**Bridge Technical Committee - Structures Design & Construction Subcommittee**  
**Meeting 4/21/2021 Sign In Sheet**

## Bridge Tech Committee – Design & Construction Subcommittee Meeting

**Date:** April 21, 2021

- Example – Concrete Overlay Detailing at Expansion Joints

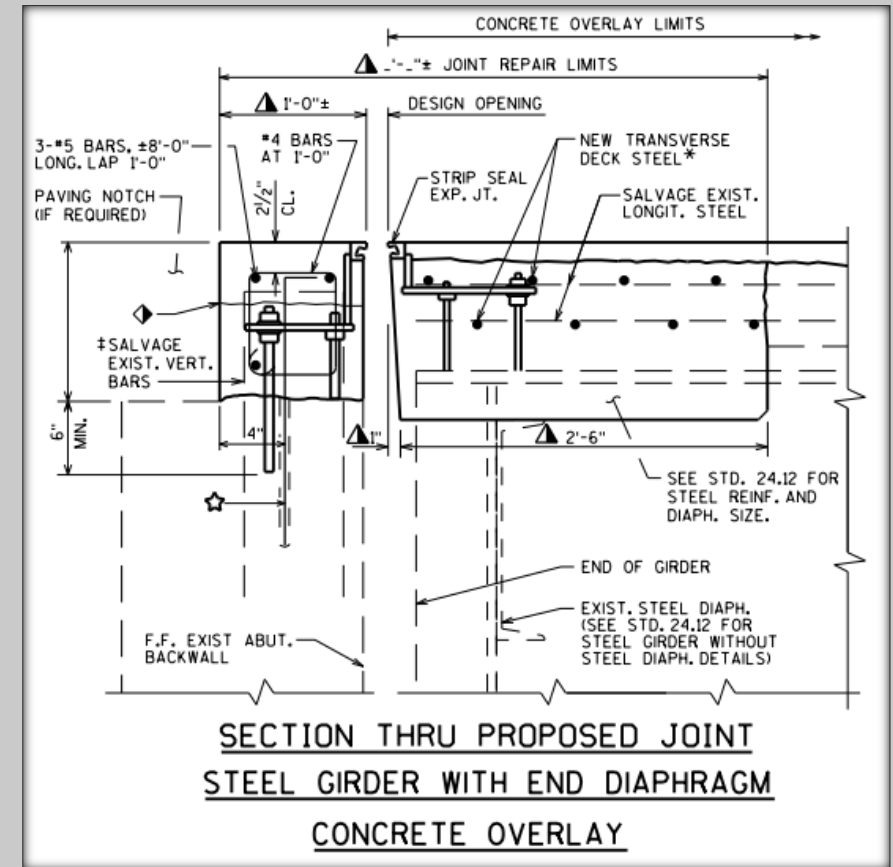
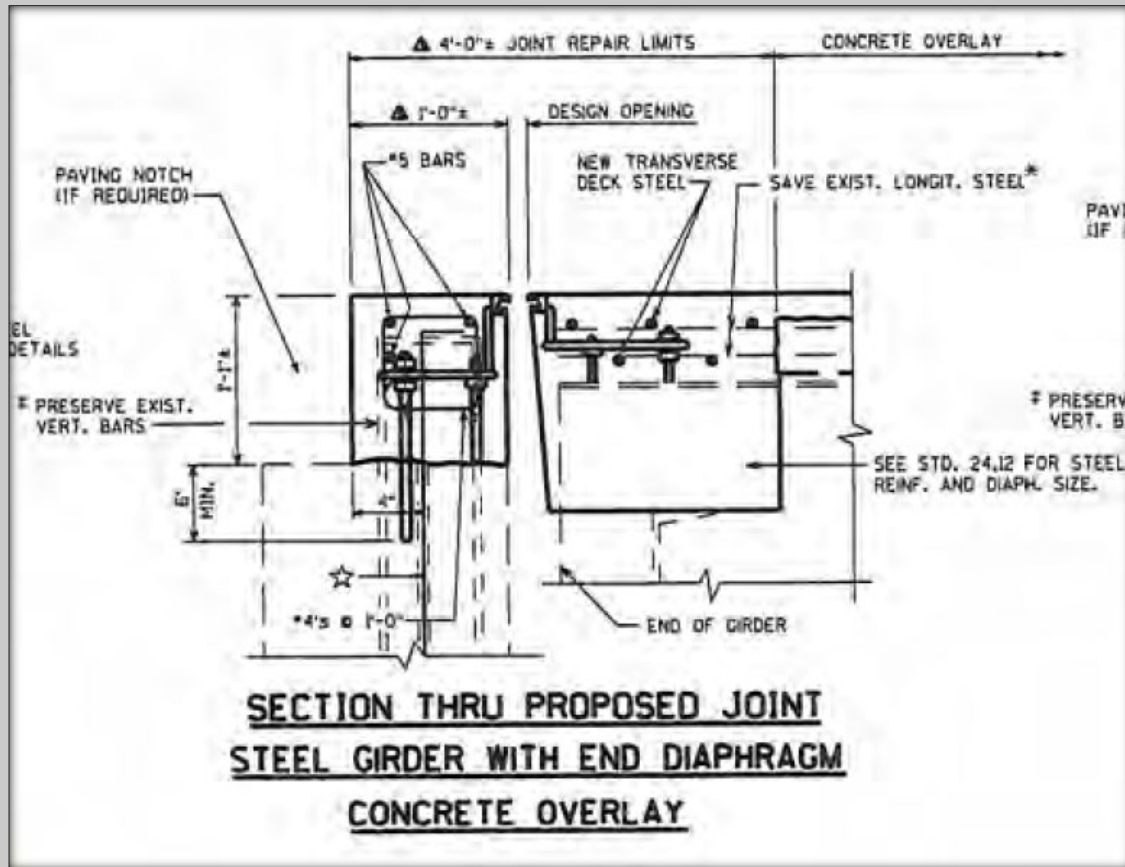
- Example – Concrete Overlay Detailing at Expansion Joints

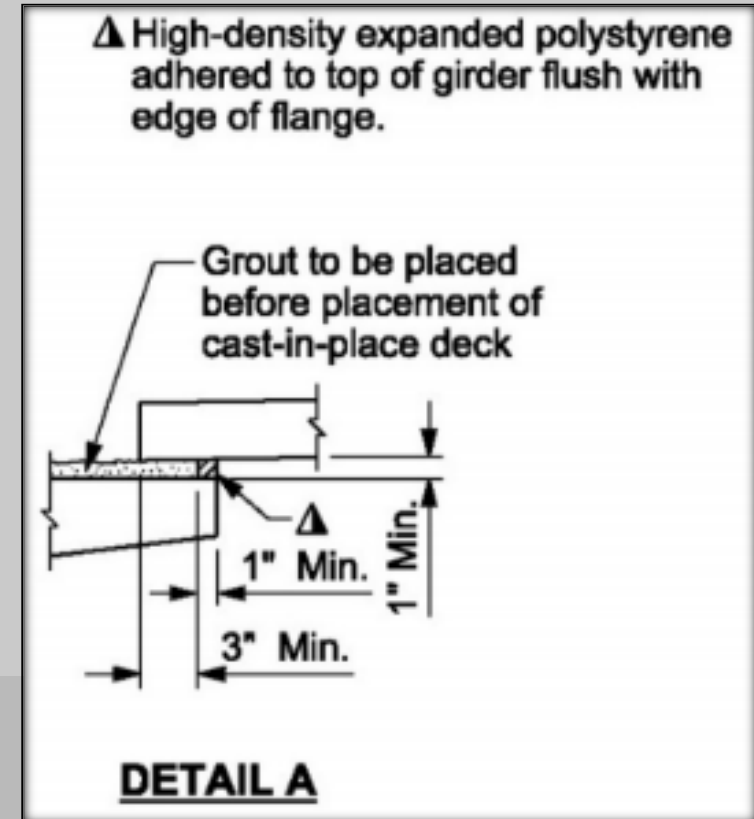
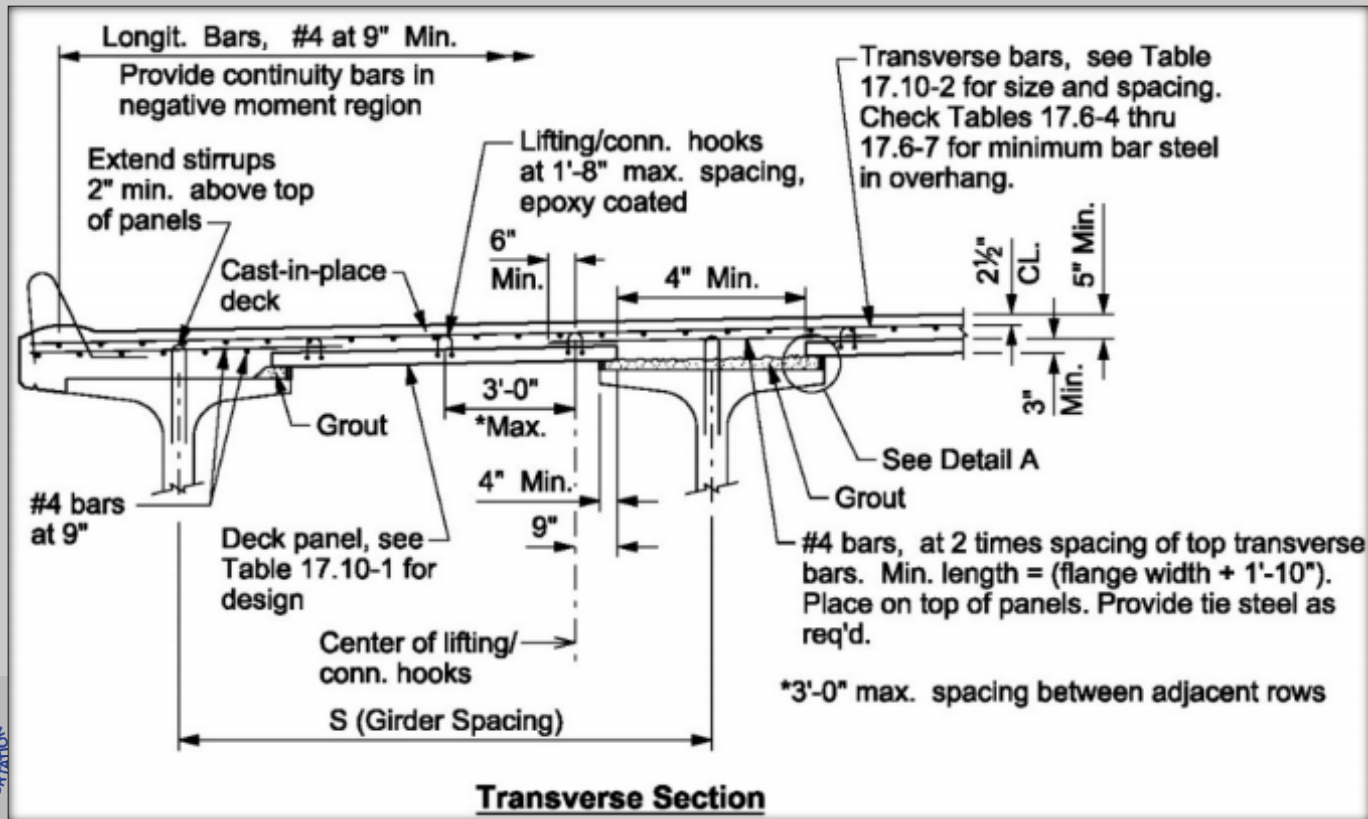
2021-04: BOS is looking to get any updated thoughts/opinions on whether 3D models would have any benefit to industry. Jason Samz indicated that ZTI is moving towards 100% 3D models for internal construction engineering and that they would gain value from receiving models from structures engineers. Jason indicated that they'd get value out of "for information only" files as it is better than starting their models from scratch. Laremy Sacia indicated that Lunda has not gone down the path of 3D models to date as they haven't been required.

- 3D Models/Plan Details
  - In 2016, BOS inquired with industry on their thoughts with potential use of 3D
  - At the time, industry indicated that 2D plans were sufficient and that they didn't see significant benefit in moving to 3D models for structures
- Any updated thoughts from industry on potential benefits of 3D in structures plan production?
  - What are you already doing, if anything?
  - Using 3D fabrication with your subs?
  - Other?

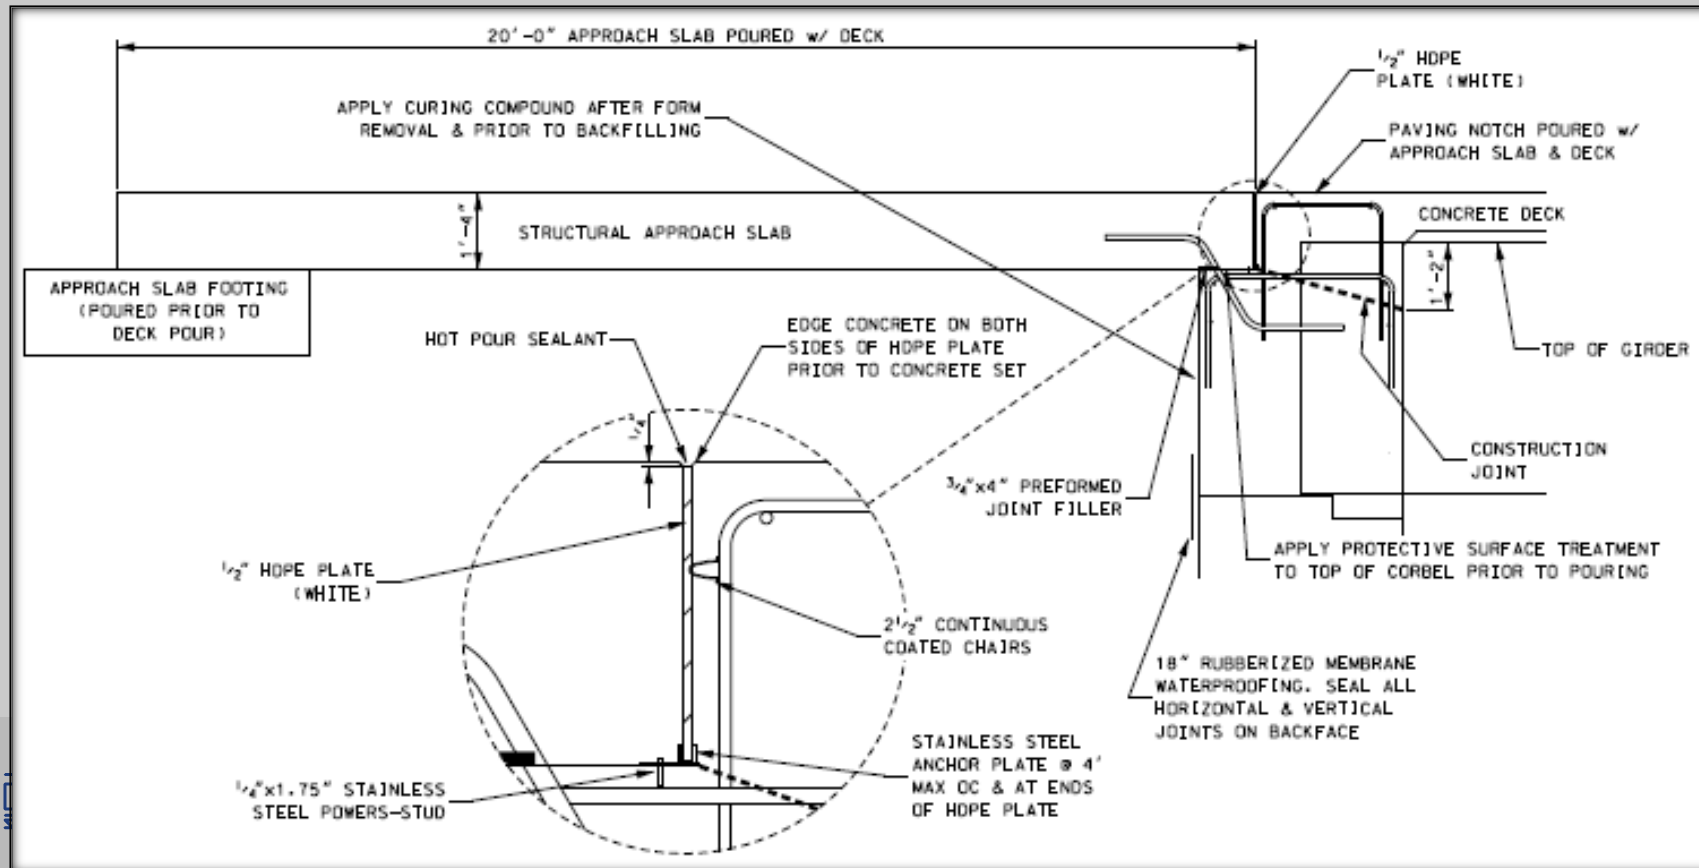
Industry would like to have more clarification on what will/will not be allowed for the different levels of removals as WisDOT/WDNR enforcement has not been consistent in the past. Aaron discussed the current STSP's and the future Standard Spec Bid items that are used to cover these structure removals. Aaron also discussed updated CMM guidance that has been/is being developed to assist with statewide consistency on project enforcement. If additional coordination is needed, BOS can be engaged for project-by-project discussions, but more guidance that can be provided to

- Demolition Means/Methods Involving DNR
  - As of October 2021 Lettings, the “Removing Old Structure” Bid Items are Moving to the Standard Spec
  - Removing Structure Over Waterway Remove Debris (Structure)
    - Used when not able to remove without dropping, not env. sensitive waterway, etc.
  - Removing Structure Over Waterway Minimal Debris (Structure)
    - Used when able to remove without dropping, not env. sensitive waterway, etc.
  - Removing Structure Over Waterway Debris Capture (Structure)
    - Used when additional protection is required due to env. sensitive waterway

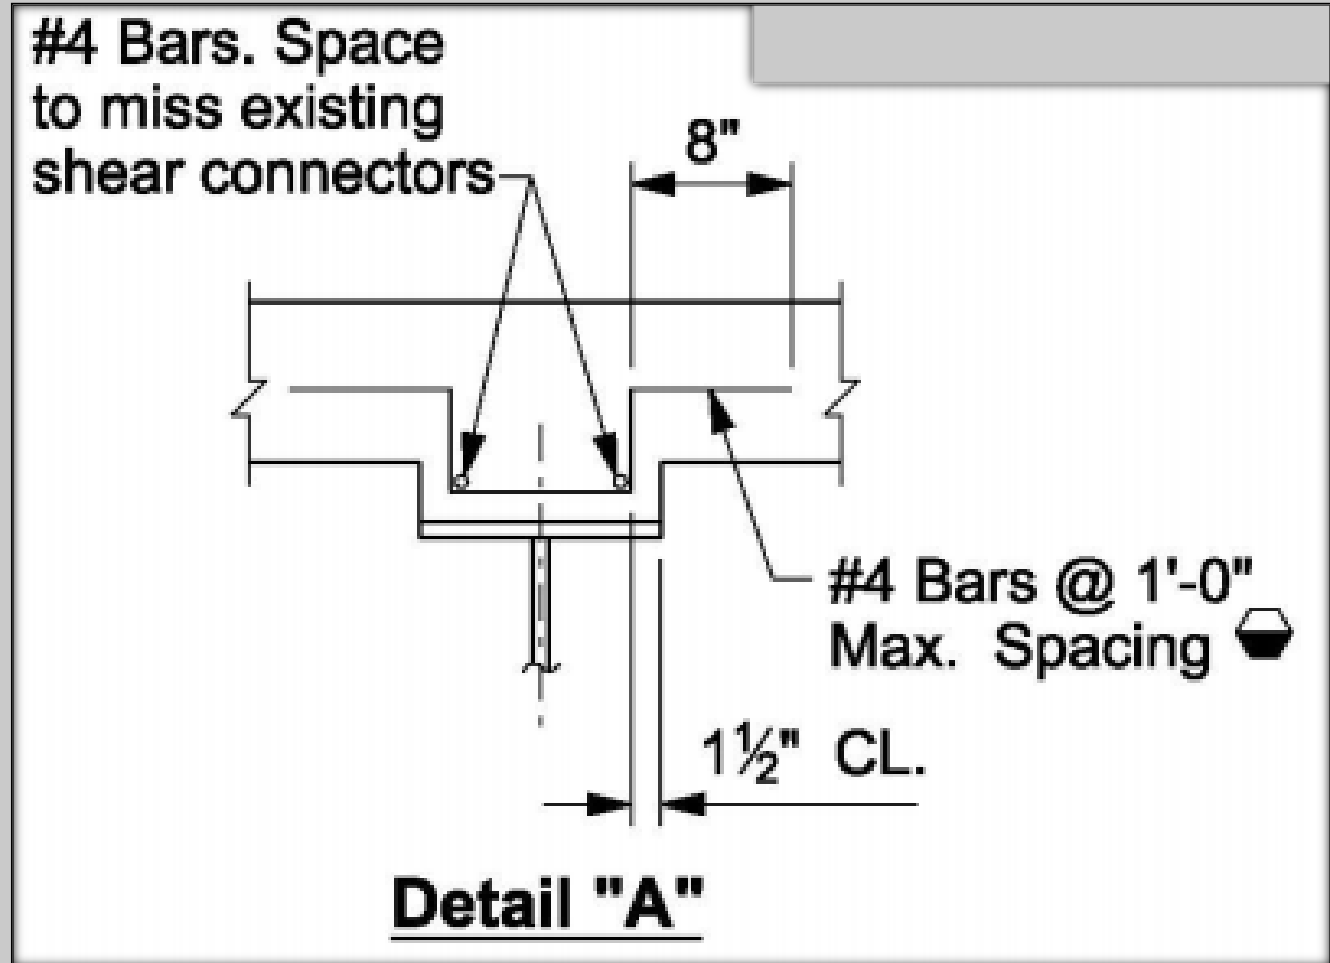
Industry didn't indicate that there were particular project situations where removal of the plan-detailed hat bars for taller shear studs would be beneficial. No significant discussion on this topic.

- Elimination of Hat Bars on Steel Girder Bridges
  - Have been inquiries about replacing hat bars shown in plans with additional shear studs
  - Industry input – what situations would benefit from this type of allowance
